**RFP 2025-02  
REQUEST FOR PROPOSALS  
FOR THE  
RENOVATION OF ROCKLAND GREEN ADMINISTRATIVE HEADQUARTERS  
AND  
CONSTRUCTION OF AN IMMERSIVE THEATRE EXPERIENCE  
AT  
172 MAIN STREET IN NANUET, NY 10954**

**To:** All Potential Proposers  
**From:** Rockland Green  
**Subject:** Addendum Number 3  
**Project:** Rockland Green Renovation & New Immersive Theatre Experience at 172 Main Street, Nanuet, NY 10954  
**RFP No.:** RFP 2025-02  
**Date:** April 10, 2025

This Addendum Number 3 is issued to modify the Request for Proposals No. 2025-02 (the “RFP”) for the above referenced project. All potential Proposers are hereby notified of the following change:

© COPYRIGHT, MICHAEL SHILALE ARCHITECTS, ALL RIGHTS RESERVED.  
 Drawing Title: **ELECTRICAL FIRST FLOOR - INSTALLATION**  
 Drawing No.: **E101**

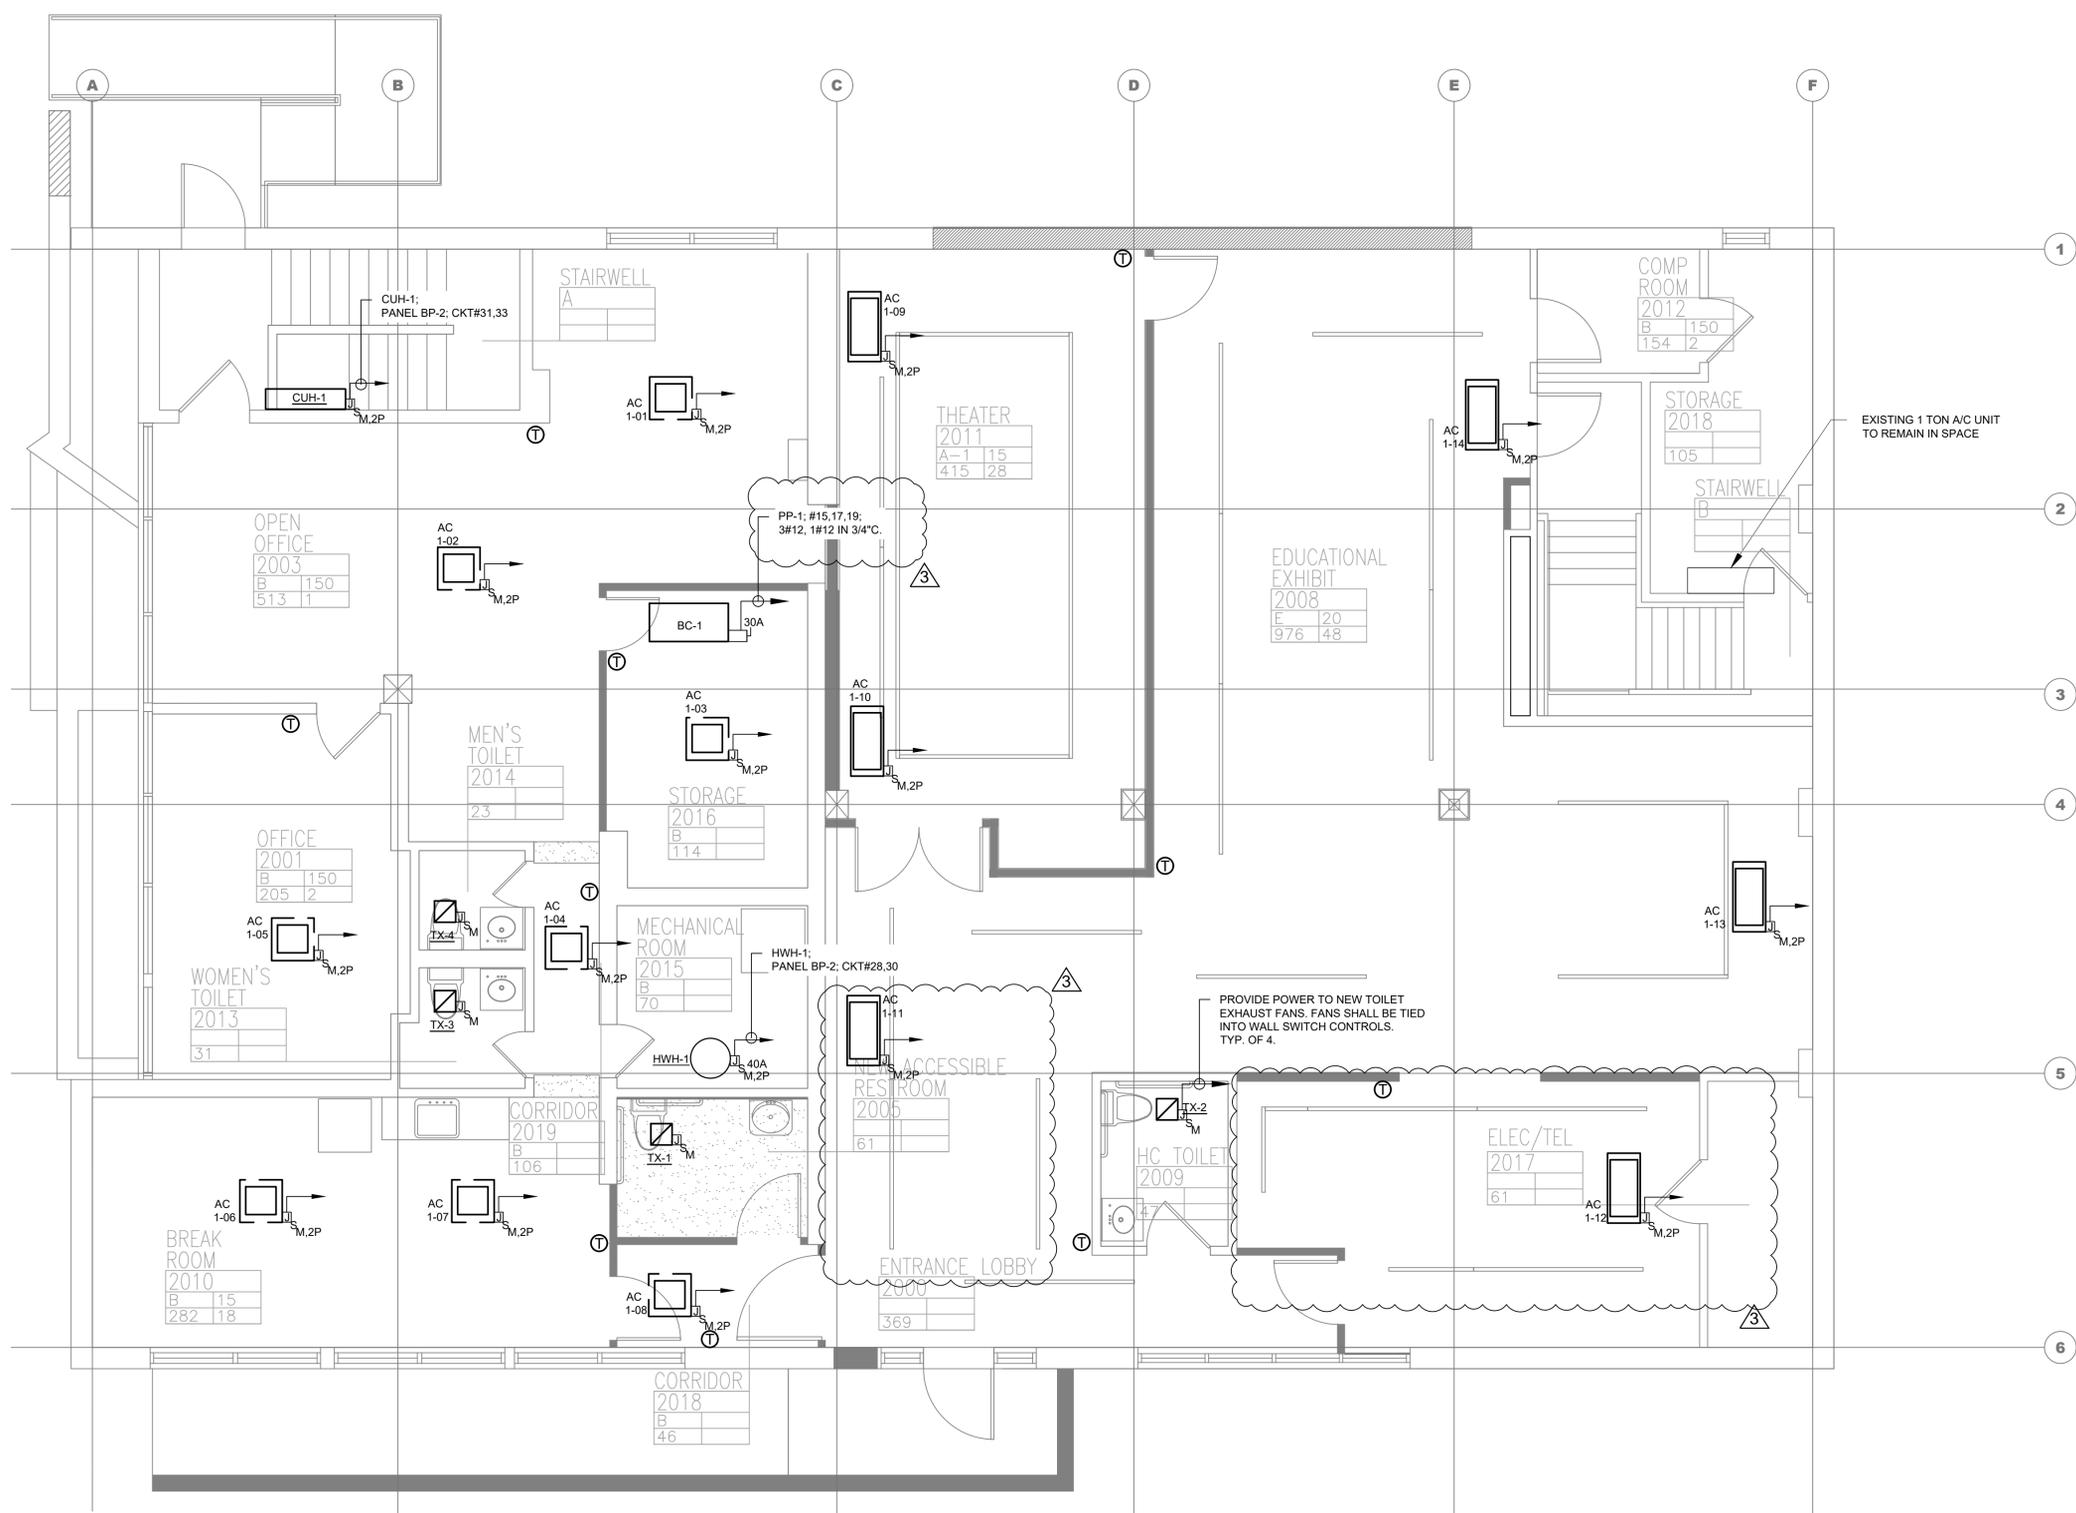
- E001 Revised Communication Symbol list.
- E101 Revised floor plan to include revisions coordinated with Theater, Solar, and Mechanical changes.
- E111 Revised floor plan to include revisions coordinated with mechanical changes.

Drawing Title	<b>ELECTRICAL SITE PLAN</b>
Drawing No.	<b>E104</b>

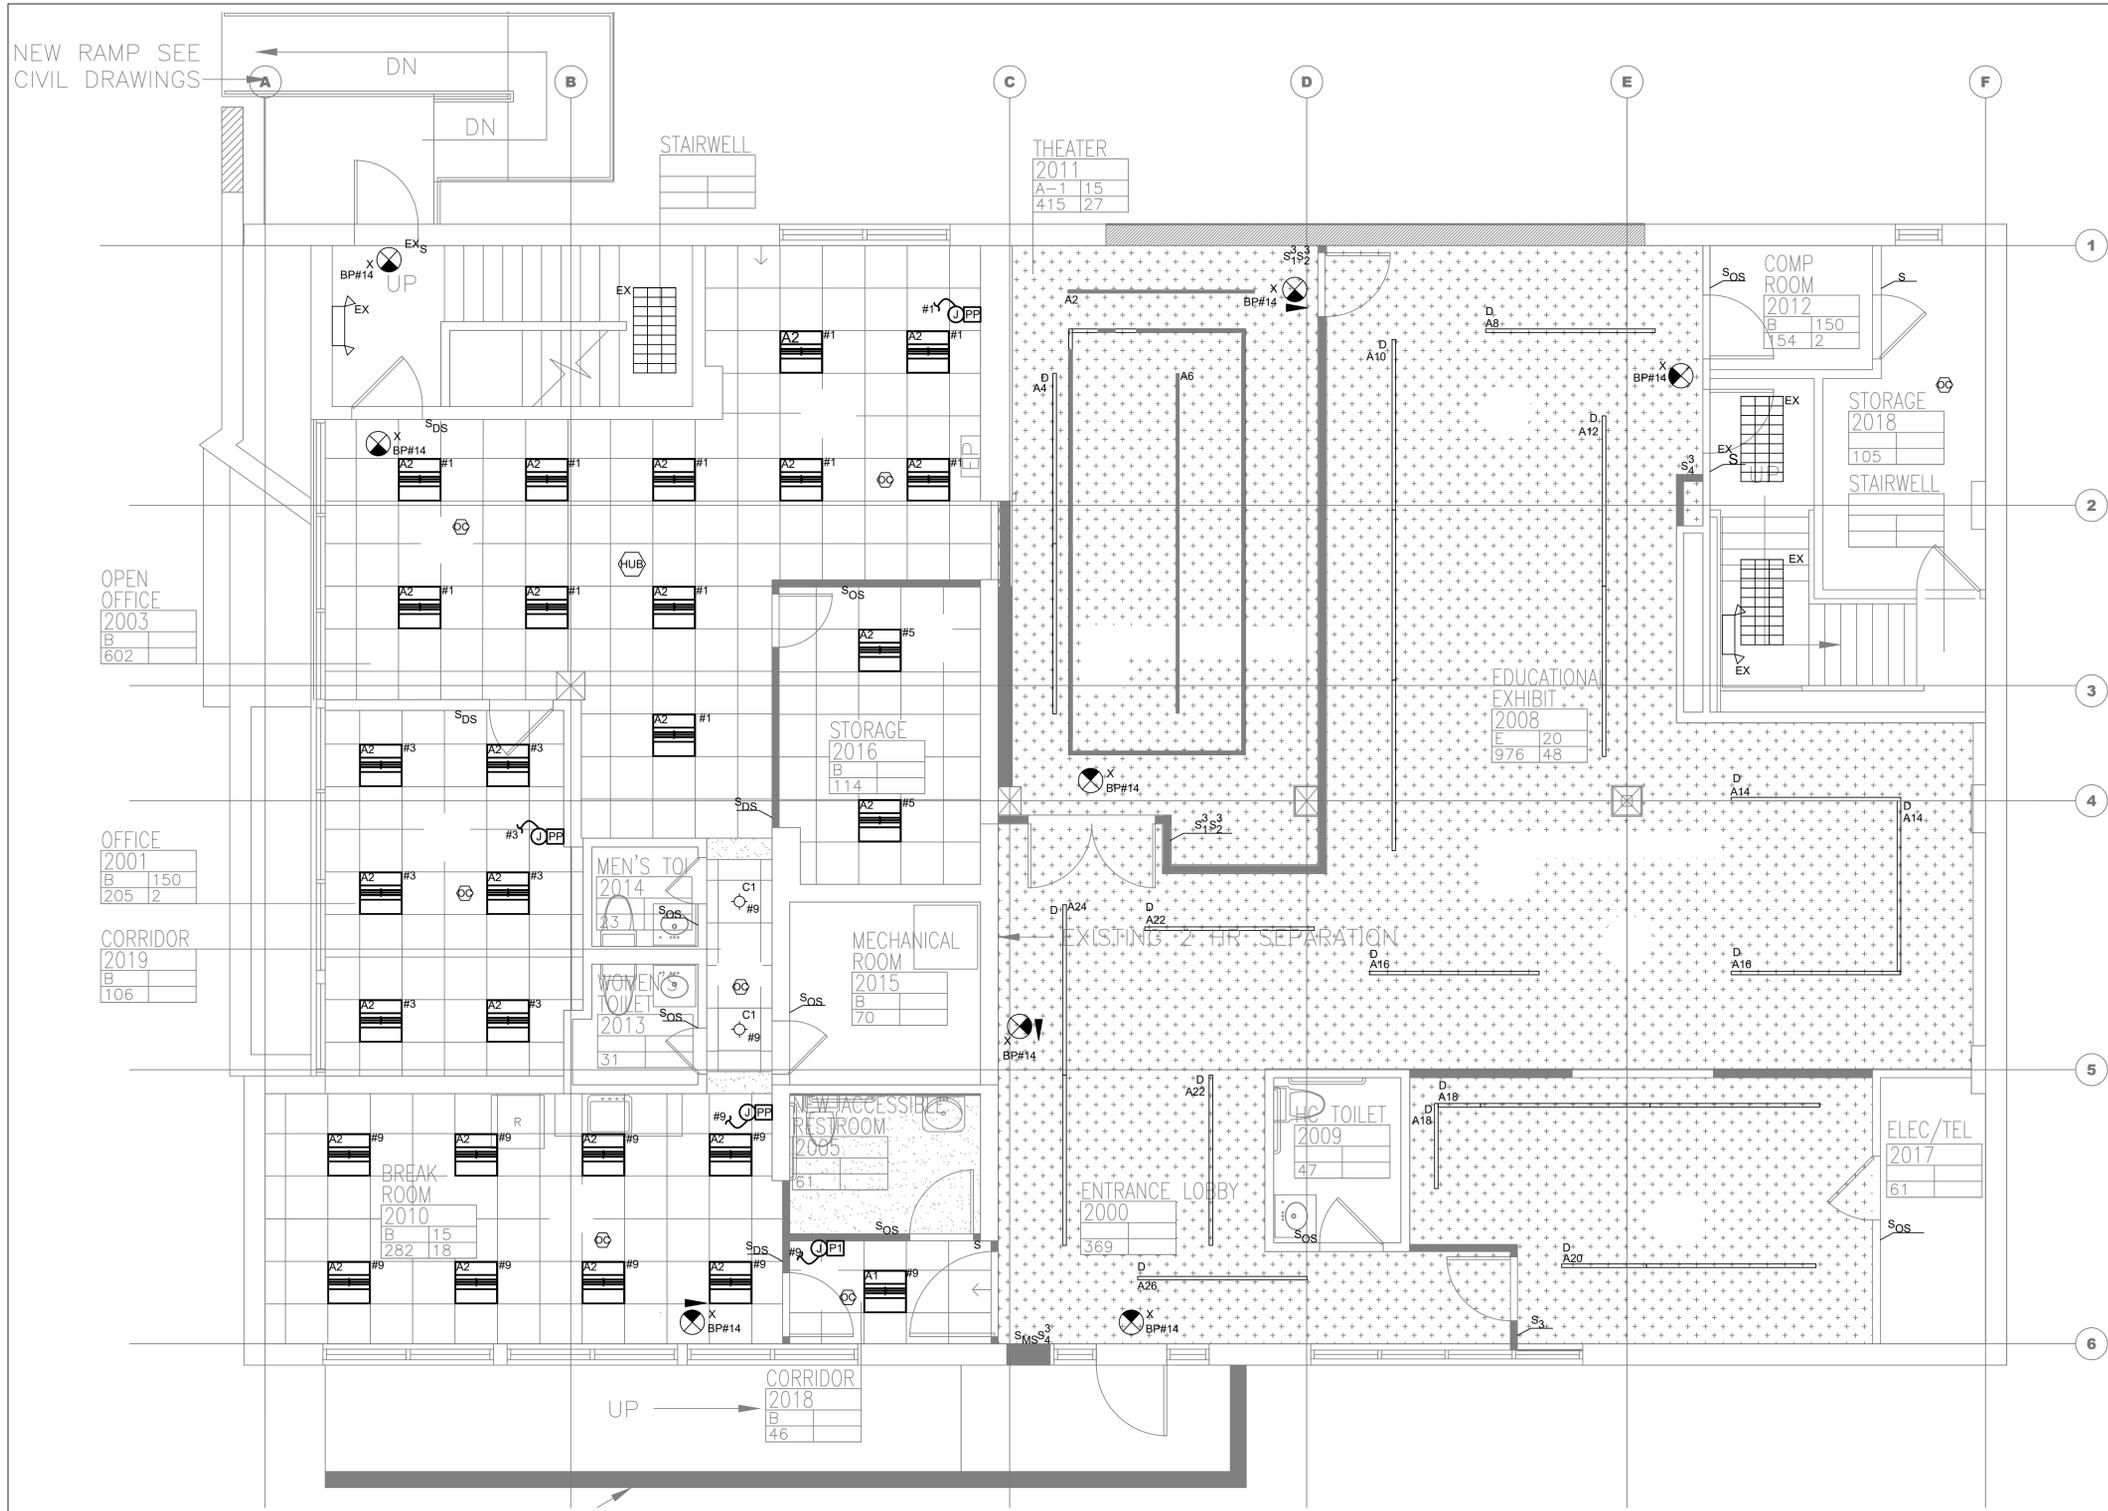
- E103 Revised floor plan to include revisions coordinated with Solar and mechanical changes.
- E104 Revised floor plan to include revisions coordinated with Site design.

Drawing No.  
**FA001**

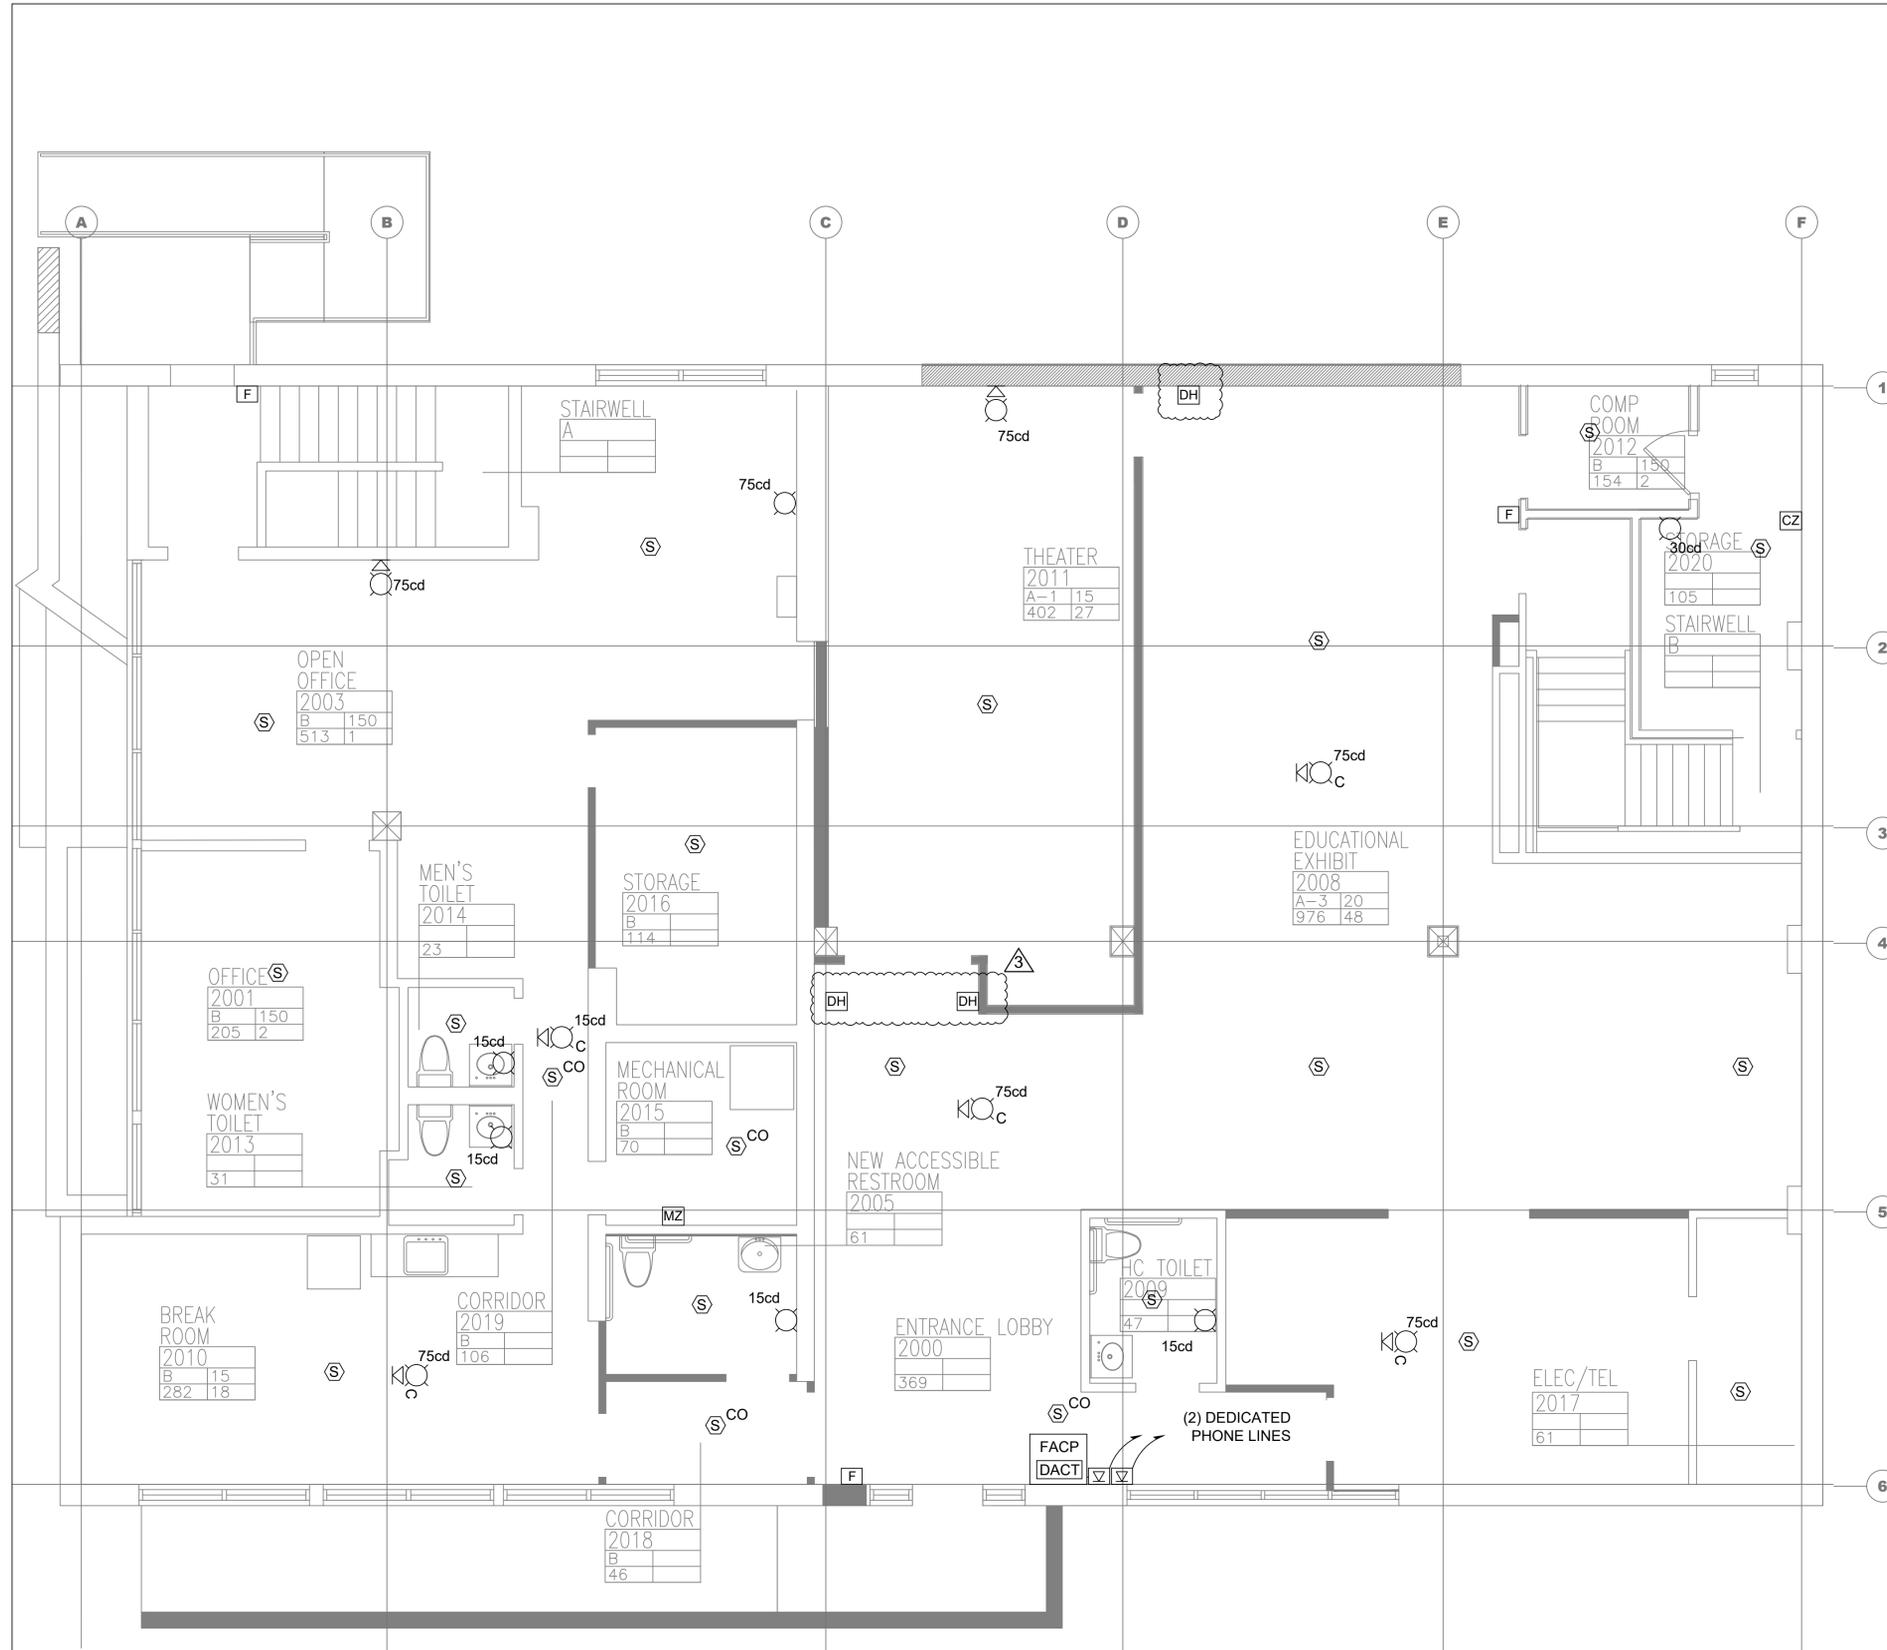
- E402 Revised panel schedule to include revisions coordinated with mechanical and theater changes.
- FA001 Revised symbol list to include door holders.
